Staff Report

To: Salt Lake City Planning Commission
From: Casey Stewart; 801-535-6260; casey.stewart@slcgov.com
Date: May 17, 2018 (For May 23 hearing)
Re: Petitions PLNSUB2017-00135 & 00179 EVO Planned Development and Preliminary Plat

PLANNED DEVELOPMENT & PRELIMINARY PLAT

PROPERTY ADDRESS: 578 & 610 N West Capitol Street
PARCEL ID: 08-36-230-016 & 08-36-230-026
MASTER PLAN: Capitol Hill Master Plan
ZONING DISTRICT: SR-1A (Special Development Pattern Residential)

SITE PLAN

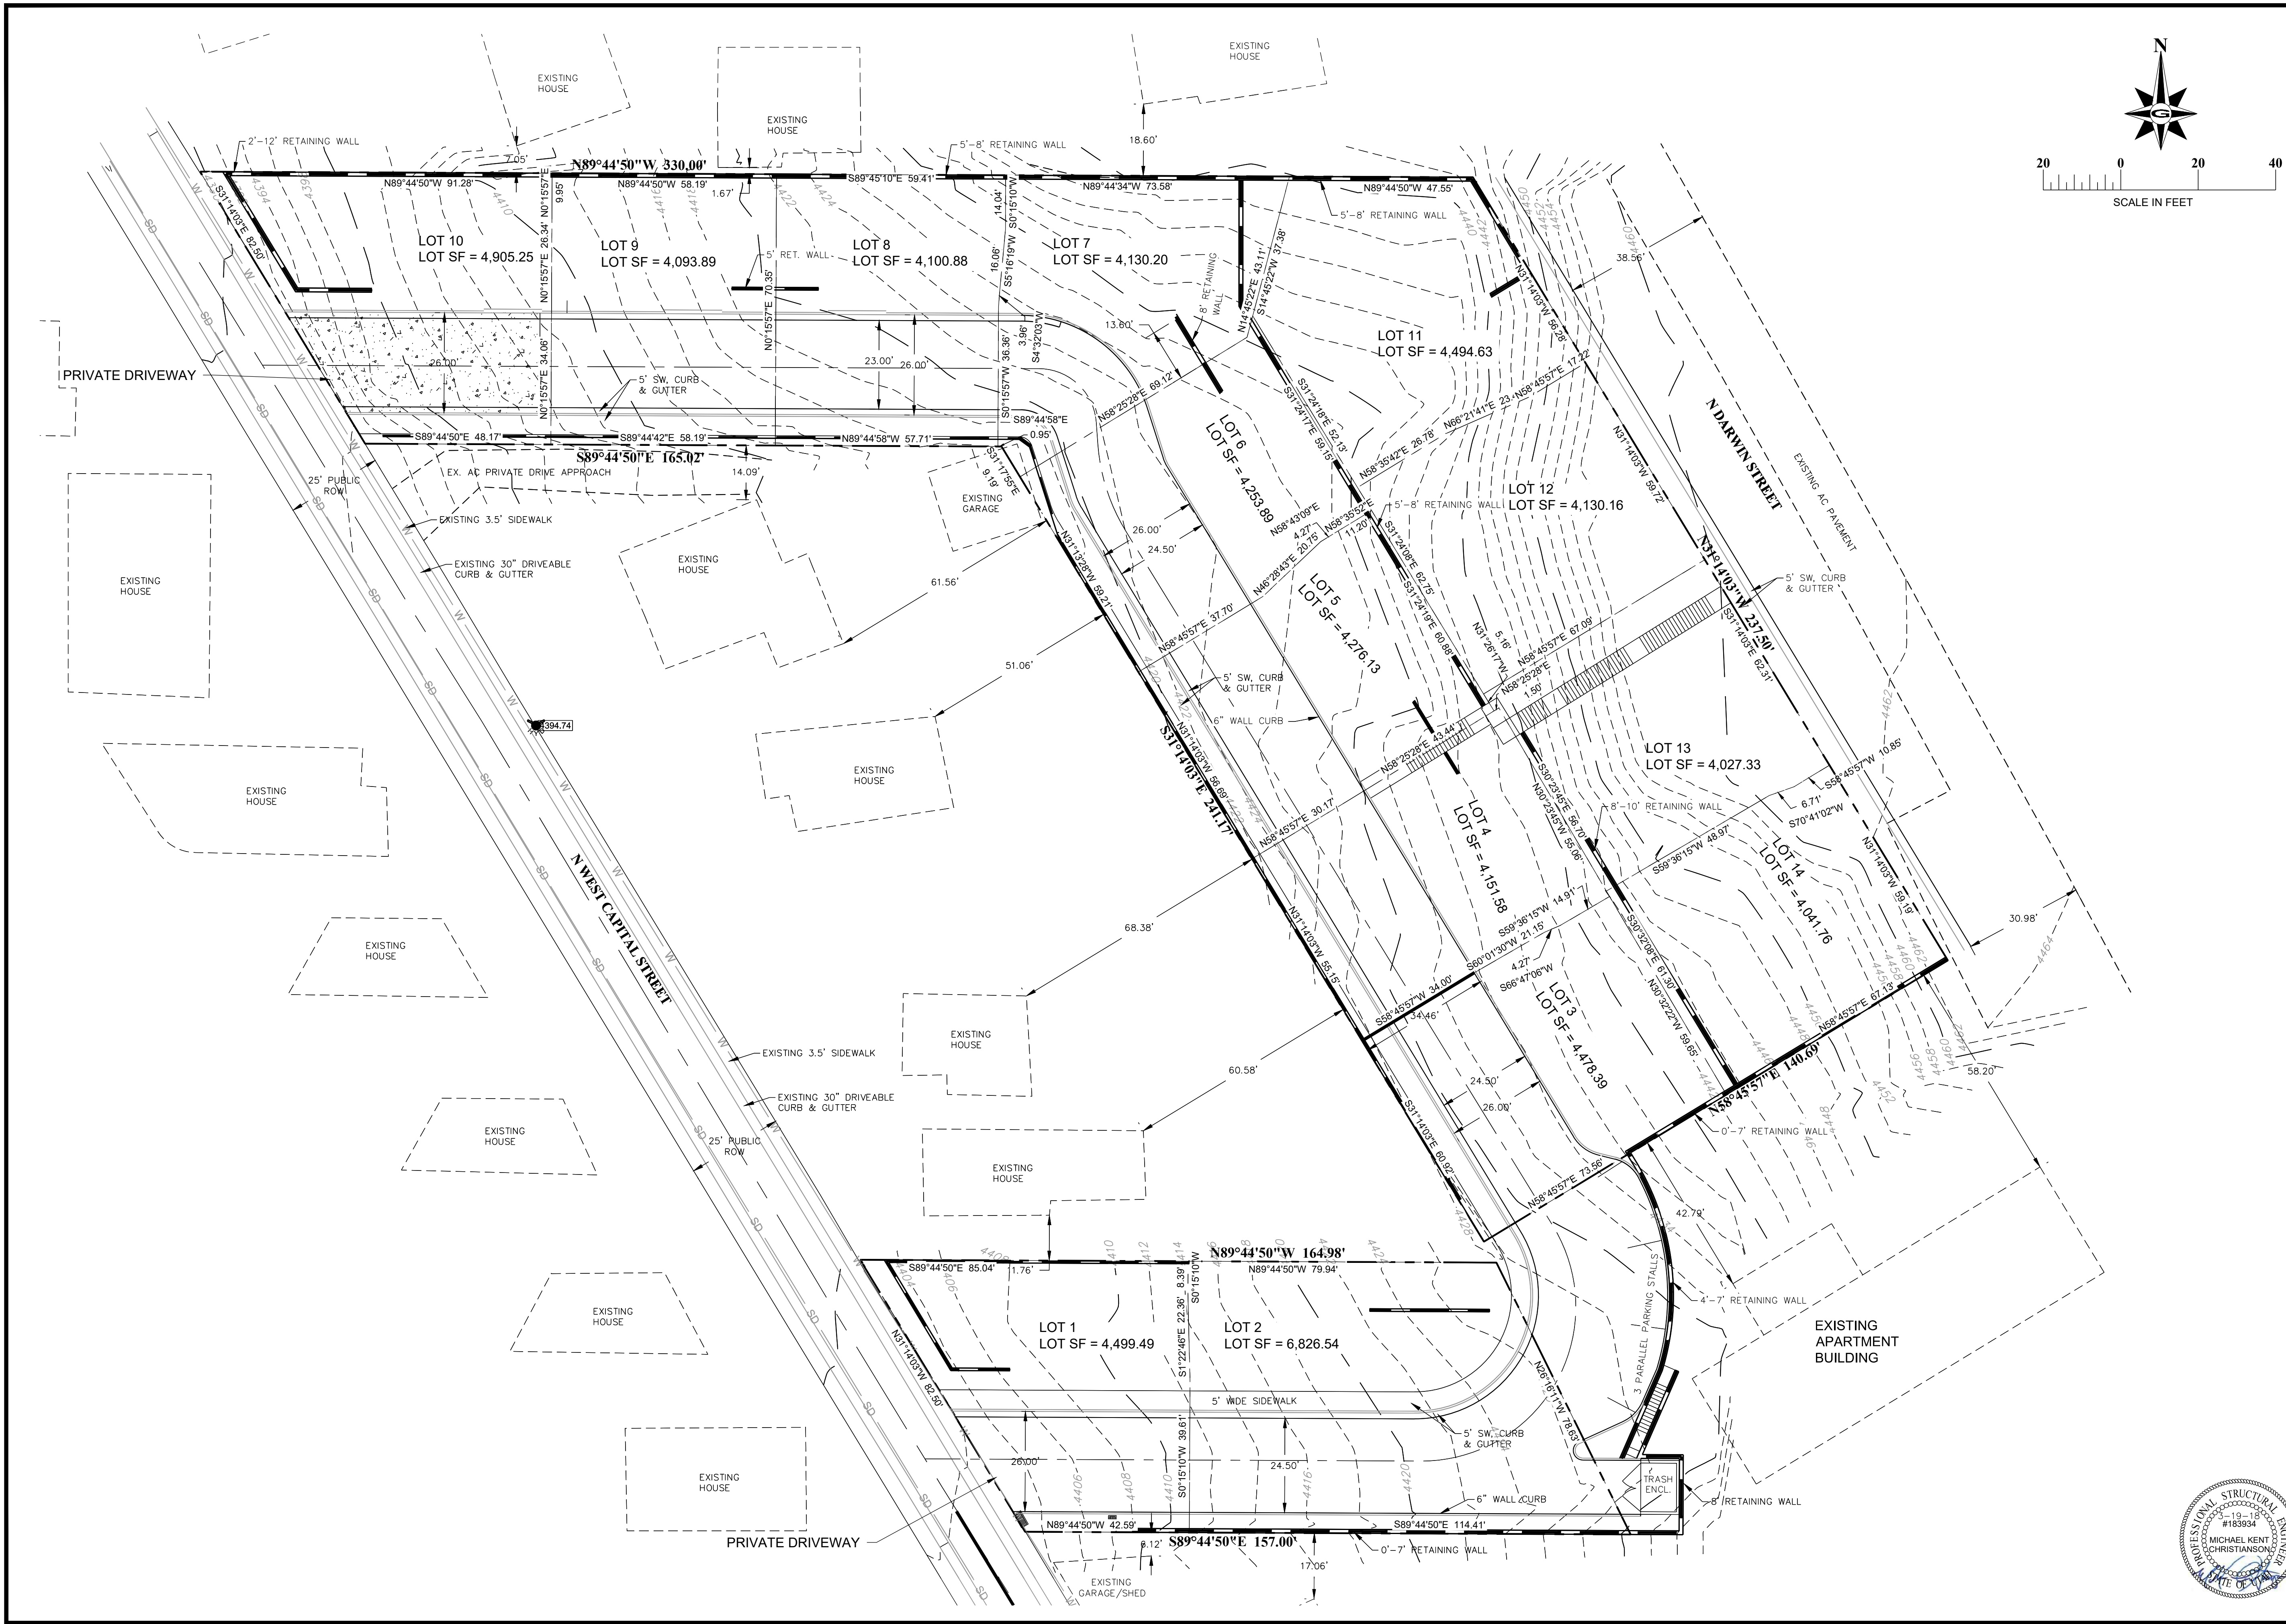
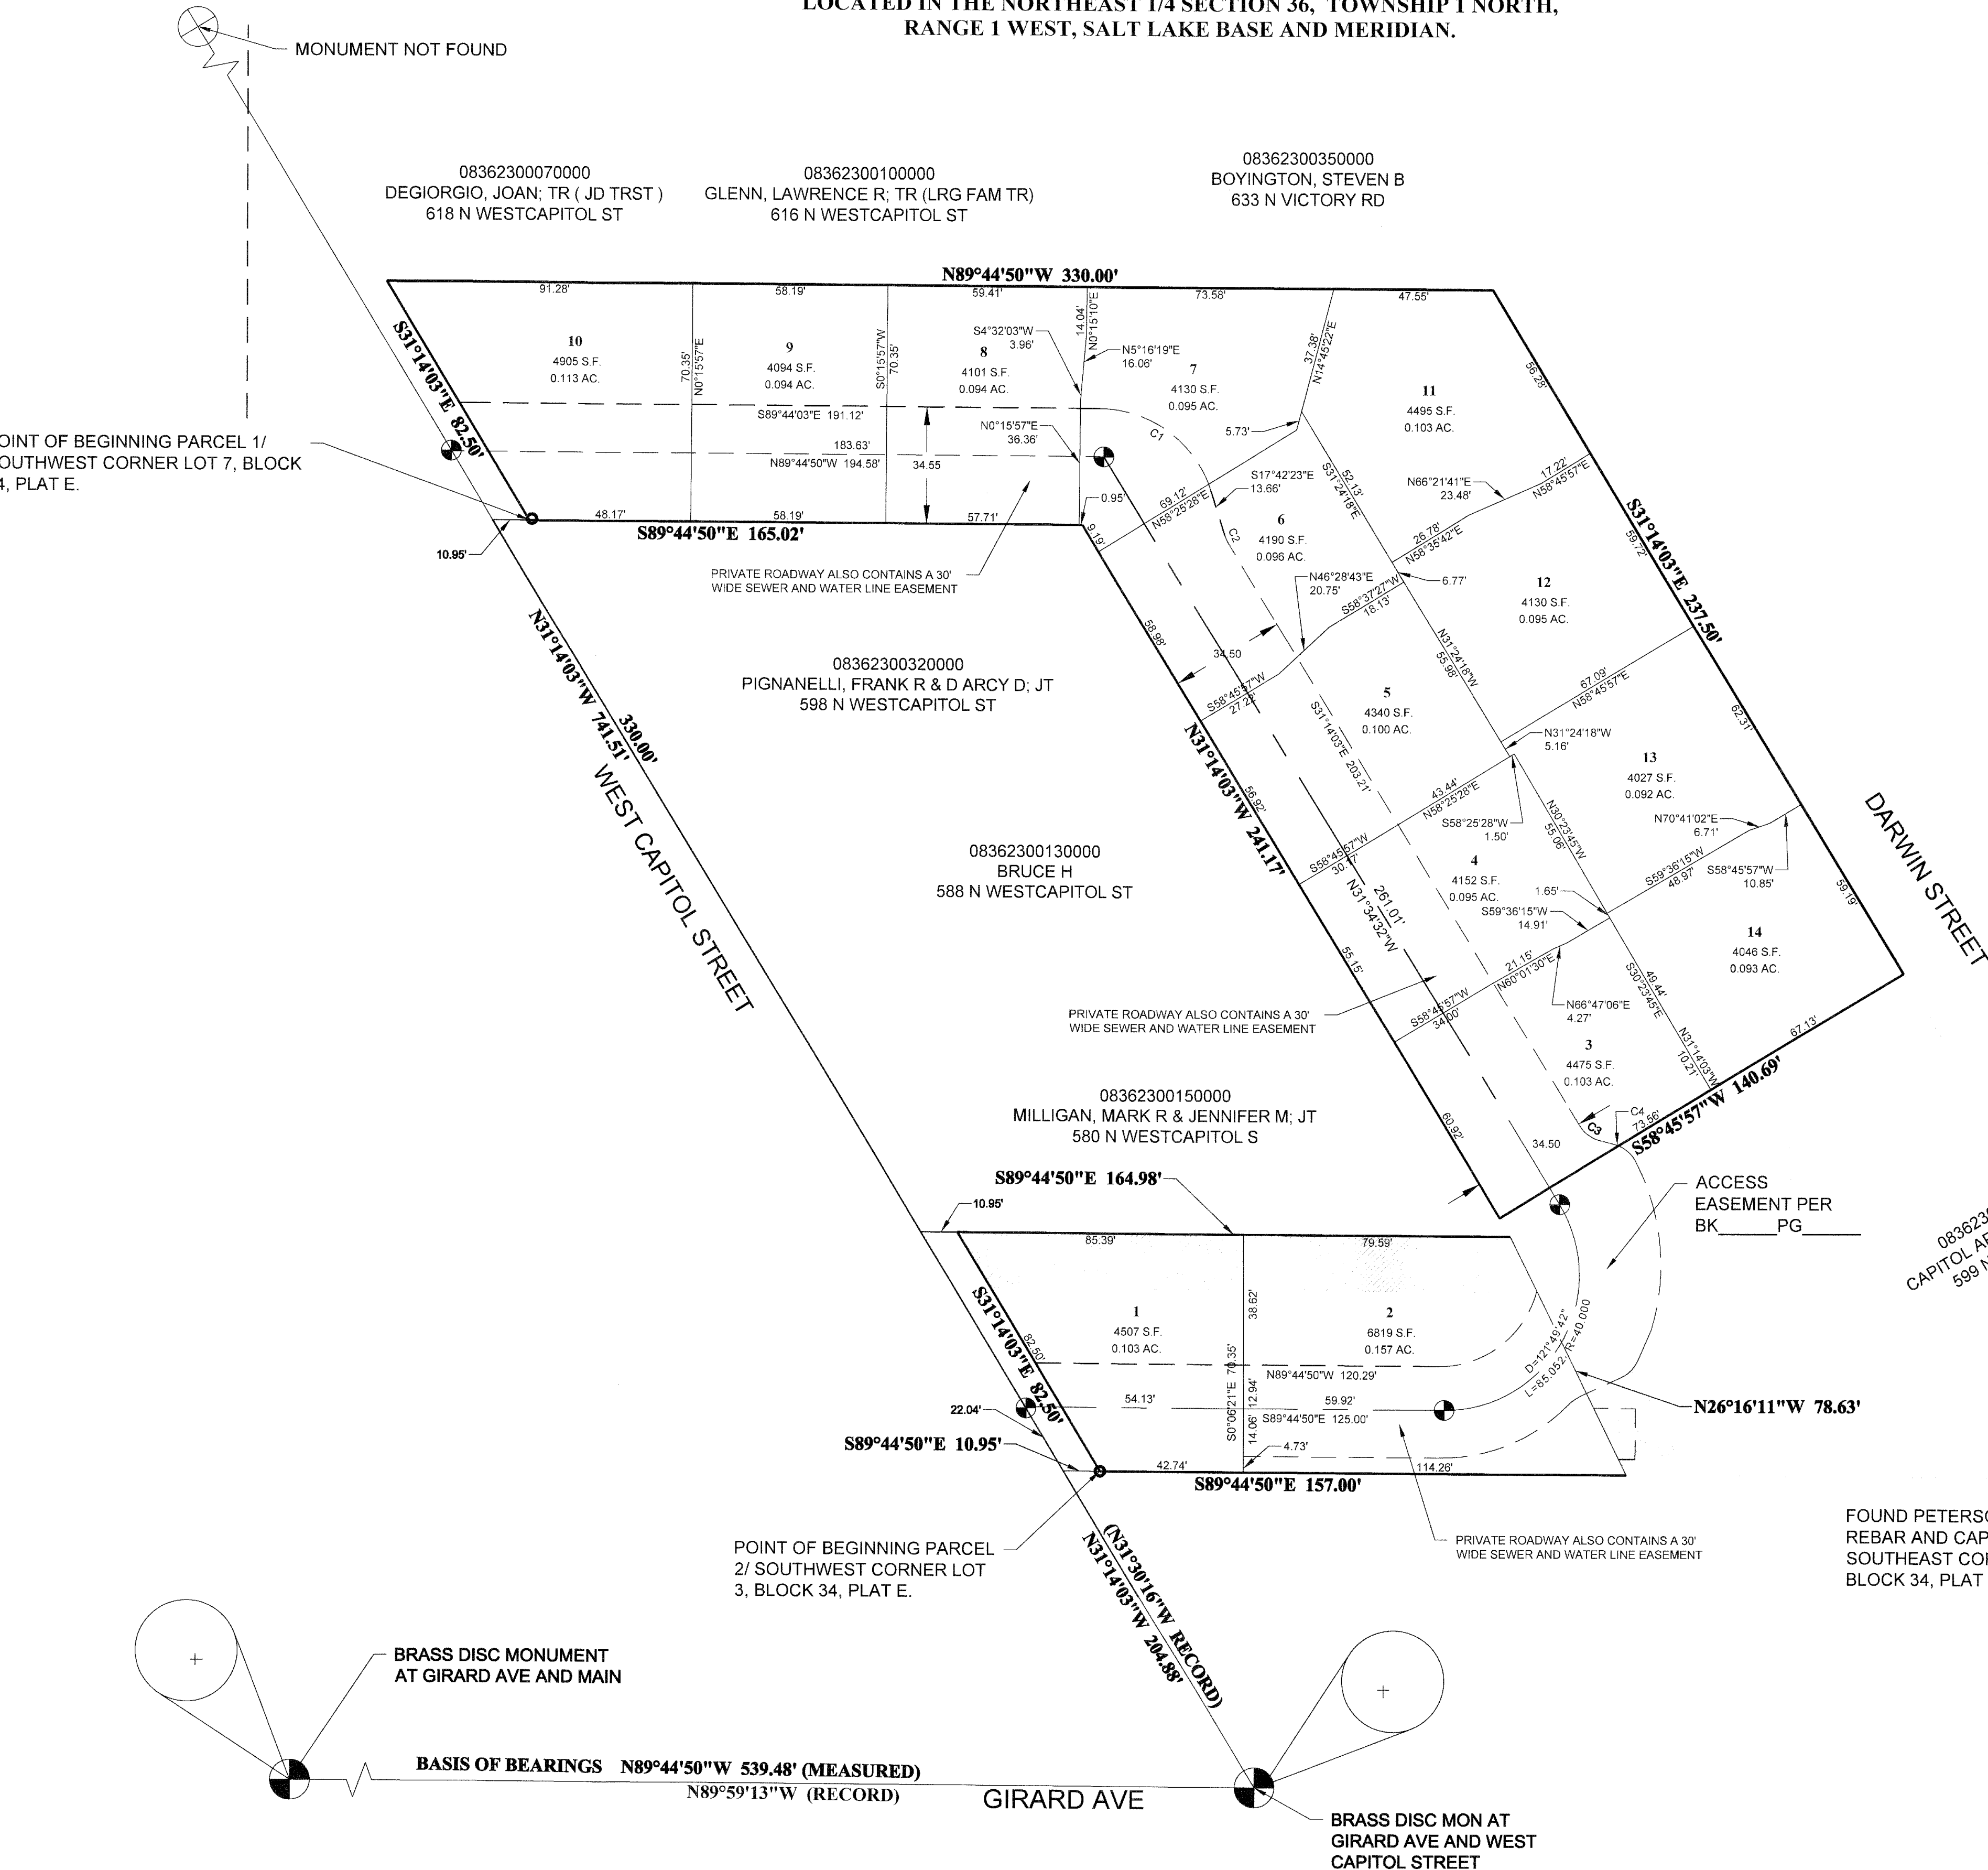
1. Ensure that storm sewers are adequate or will be upgraded to handle anticipated runoff for both this project and the proposed Victory Rd. Townhomes (see letter of Nov. 20, 2017 attached).
2. Ensure that any other utilities that would be shared by the two developments are adequate or will be upgraded.
3. Provide as much additional off-street parking as possible for visitors to avoid increasing parking on West Capitol St. This should also be required of the Victory Rd. Townhomes project. This is especially important given the abandonment of 11 feet of right-of-way requested by the latter development.
4. Please provide an interpretation of Section 21A.48.080 B, which prohibits impervious surfaces in landscape buffers as it applies to this project. We believe that the private drives in the front yards of several of the buildings may violate this section.

1. We would like to request that the Developer come to our April 18th meeting (at 6:30 pm) to present the project and answer questions.
2. Another 14-unit Planned Development on West Capitol St. was recently submitted to our Council which we commented on in a letter to the City Council, copied to Joel Paterson, on November 20, 2017. West Capitol St. is very narrow and this earlier project involved abandoning 11 feet of right-of-way. We are concerned that the present project, combined with the earlier 14 unit development, will create excessive traffic and parking demands on West Capitol St..

3. Several pieces of information were not included that are needed for a proper evaluation of the project. These are:
 - a. A site plan showing the private lane, lot lines and buildings.

- b. A grading plan. The Council is very concerned about the amount of soil to be exported during the construction of the project.
 - c. Accurate plans and elevations of the buildings.

- d. A site section showing how the buildings will be integrated into the slope.
4. We are concerned about the capacity of the storm sewers in West Capitol St. and Clinton Ave. These two Planned Developments will add considerable runoff that these sewers may not be designed to handle.

The preliminary plat needs to provide easement for utilities crossing the property lines even if it is internal to the building. An agreement or homeowner association will need to provide for maintenance and payment of utility improvements.

Thank you for these comments. In response to your item #4, the chapter you are referring to does not apply to this project. I refer you to the "Applicability" paragraph at the very beginning of that chapter (21A.48.080.A). The proposed project is a residential project, which is surrounded by existing residential uses, thus they are similar uses. A "landscape buffer" applies when dissimilar uses are involved, to buffer against increased impacts from dissimilar uses. Furthermore, you'll notice that the SR-1A zoning district is not listed in that chapter.

- 1 & 2 are required anyway as part of the projects development permits. All storm drainage and utilities are required to meet the city's standards, which will address these concerns. That is handled during the construction permit review.
- 3 The required parking minimum for twinhomes is 2 stalls per unit (1 per bedroom up to a max of 2). The project meets this standard with the 2-car garages for each unit and unless the planning commission determines that additional area should be set aside for parking, no additional parking would be required.
